Northern Beaches Council
Attention: Mr Daniel Milliken
(submitted online at the NSW Planning Portal at <https://www.planningportal.nsw.gov.au/>)

17 February 2023

Response to Request for Information on Survey and Mean High Water Mark Matters for DA2021/1612, Relating to Construction of Upgraded Coastal Protection Works at 1190-1196 & 1204 Pittwater Road Narrabeen

Figure 2: MHW positions seaward of the subject properties from 1941 to 2022 (aerial photograph taken 22 November 2022)

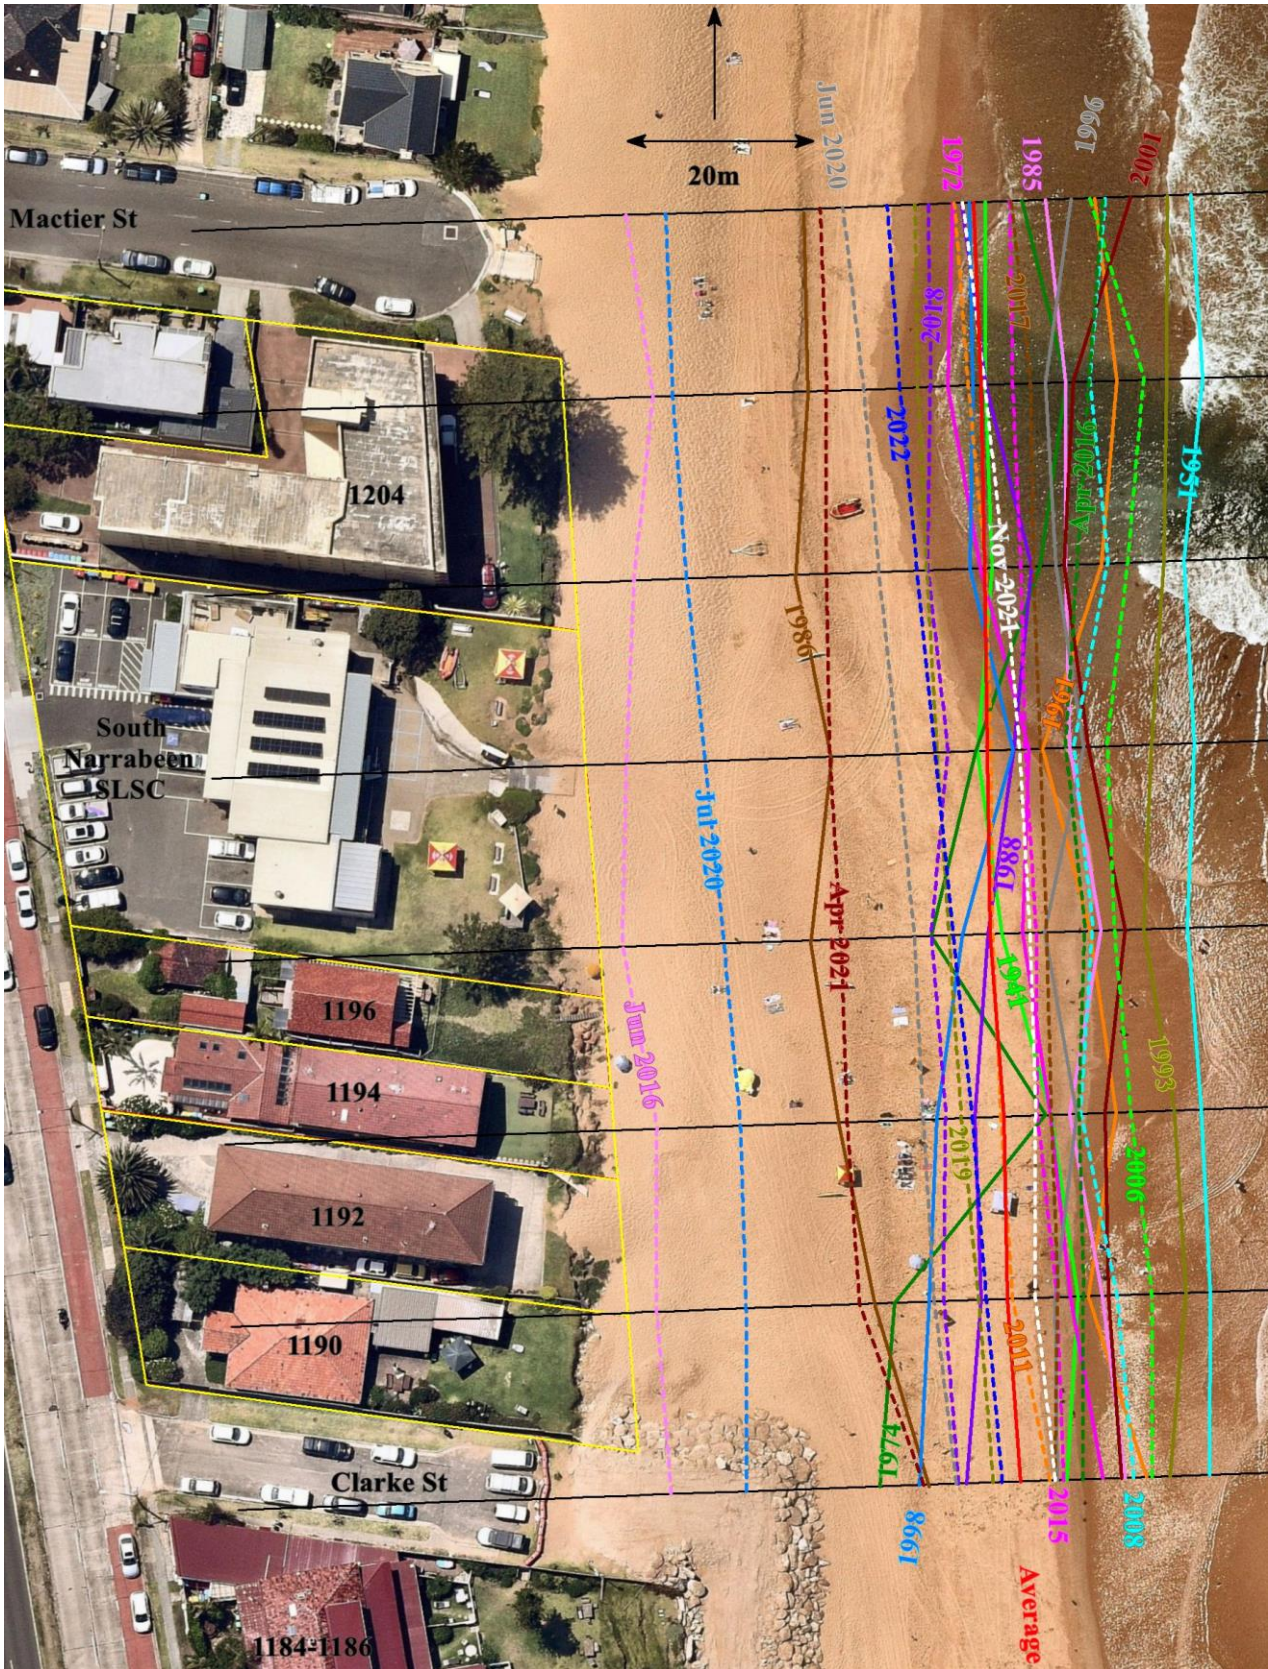
1. The Applicant must provide Council with a Survey, prepared by a suitably qualified Surveyor, prior to the approval of any works, which shows the exact location of the proposed works.

2. All Surveys are to show relevant boundaries in accordance with Part 2 of the *Surveying and Spatial Information Regulation 2017* and identify each of, the existing mean high water mark, the original mean high water mark and any former mean high water mark by reference to bearings and distances from the boundary. Note: If there is a difference between the existing mean high water mark and any former mean high water mark, Council will rely on the most westerly of those lines, so as to ensure proposed works are constructed wholly within privately owned land.

3. The survey is to be accompanied by a Report from the Surveyor which certifies that the survey has been prepared in accordance with Part 2 of the *Surveying and Spatial Information Regulation 2017* and if there is a new mean high water mark shown in the survey document, the reasons for the change.

The average MHW determined from the 26 NSW Beach Profile Database MHW positions is depicted in red in Figure 2. This average MHW is located about 41m to 46m seaward of the subject properties, increasing moving north, and so happens to be similar to the 2011 MHW.

LCG Global Pty Ltd (registered surveyor Shane Lawrence) has investigated available historical MHWs, and did not find any MHWs defined as part of Deposited Plans or otherwise. However, based on the analysis depicted in Figure 2, it can be confidently asserted that the long-term average MHW in the vicinity of the subject properties is located well seaward of the properties, in the order of 44m⁴.

It is evident from Figure 2 that the 2017 and 2021 surveyed boundaries are essentially indistinguishable. The distance between the NE corner of the boundary in the two surveys is 36mm, and it is a 29mm difference at the SE corner. The two seaward boundaries are generally within 10mm of each other. In Appendix B, it is noted that the boundaries in the 2021 survey have been defined as accurately as possible, so can be considered to be exact boundaries.

In Appendix B, the surveyor has confirmed that the 2021 survey was prepared in accordance with Part 2 of the *Surveying and Spatial Information Regulation 2017*. The MHWs derived from the NSW Beach Profile Database do not alter the current right line boundaries in the property titles, as the long-term average MHW (red line in Figure 2) is in the order of 44m seaward of the subject properties.
